## Product Improvement Notification

November 17, 2015

Products: 4HP and 5HP Executive Pump Impellers

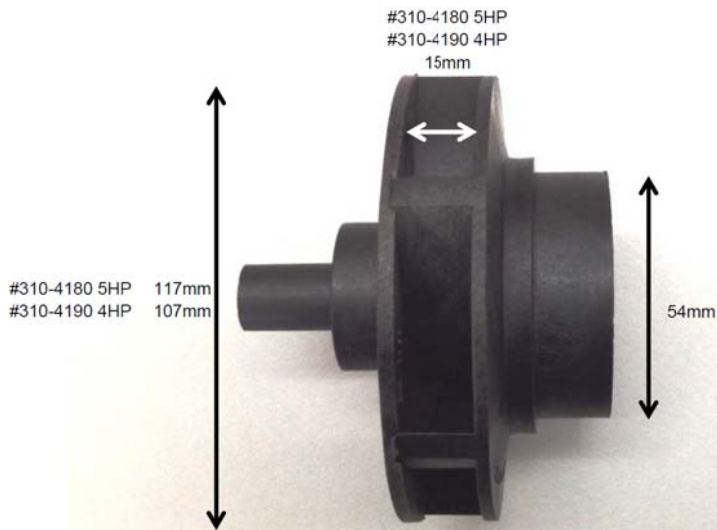
Waterway has made a change to our 4HP and 5HP Executive Pump Impellers P/N's 310-4180 and 310-4190. The change improves the impeller's concentricity, reduces vibration which reduces wear on the pump and more importantly improves performance.

The new style impellers may look slightly different, but they are retroactive with the old impellers and will fit any Executive volute housings.

These new impellers are now being made only in black for easy recognition from the old ones.

HP	Old Impeller		New Impeller	
	Dia.	Width	Dia.	Width
4HP	117mm	12mm	107mm	15mm
5HP	117mm	16mm	117mm	15mm
